Access Compliance Report

Public Rights-of-Way

(Curb Ramps)

Intersection ID: N/A	Main Street: MCCLINTOCK_RD	Cross Street: BASCOM_ST	Location: SW
ADA ID: ABDB8253B76A	Ramp Type: Perp	Initial Pass/Fail: Fail	Overall Compliance: No
		Severity Score: 12.5

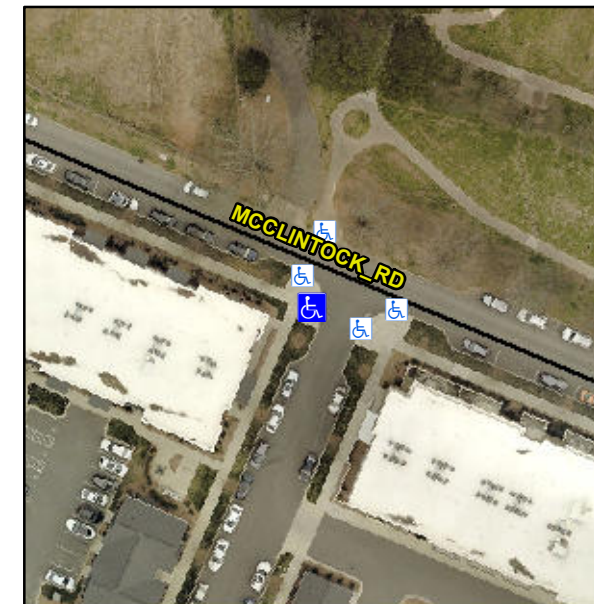
R304.2.2

Compliance	Description	Data	Compliance	Description	Data
N/A	Ramp Length (in)	130.0	No	Ramp Slope (%)	9.4
Yes	Ramp Width (in)	48.0	Yes	Ramp XSlope (%)	1.1
N/A	Flare Type LT	N/A	N/A	Flare Type RT	N/A
N/A	Flare Slope LT (%)	N/A	N/A	Flare Slope RT (%)	N/A
N/A	Flare Traversable LT?	N/A	N/A	Flare Traversable RT?	N/A
N/A	Landing Length (in)	N/A	N/A	DWS Provided?	N/A
N/A	Landing Width (in)	N/A	N/A	DWS Contrast?	N/A
N/A	Landing Slope (%)	N/A	N/A	DWS Length (in)	N/A
N/A	Landing X Slope (%)	N/A	N/A	DWS Full Width?	N/A
N/A	Landing Curb? (Y/N)	N/A	N/A	DWS Offset (in)	N/A
N/A	Shared Landing?	N/A			
N/A	Gutter Ponding?	N/A	N/A	Gutter Slope (%)	N/A
N/A	Gutter Lip Ht (in)	N/A	N/A	Gutter X Slope (%)	N/A
N/A	Painted X Walk1?	No	N/A	Painted X Walk2?	N/A
	X Walk 1 Direction	To E		X Walk 2 Direction	N/A
N/A	X Walk 1 Width (in)	N/A	N/A	X Walk 2 Width (in)	N/A
	X Walk 1 Slope (%)	2.1		X Walk 2 Slope (%)	N/A
	X Walk 1 X Slope (%)	2.4		X Walk 2 X Slope (%)	N/A

Remove & Replace Entire Ramp.
